Left Out M17 Decon NSNs

The M17 decon has two versions of the Cuyuna/2SI engine. Those engines with serial numbers below 63427 are one version and those with numbers 63427 and higher are the other.

Fig. C-28

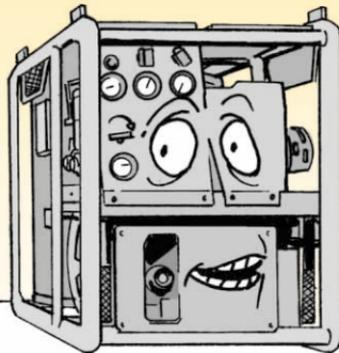
Fig C-28, Item 4, electronics amplifier, NSN 6110-01-358-7886, PN 1389, SMR PAOZZ

Fig C-28, Item 9, ignition coil, NSN 2920-01-356-6928, PN 3040, SMR PAOZZ
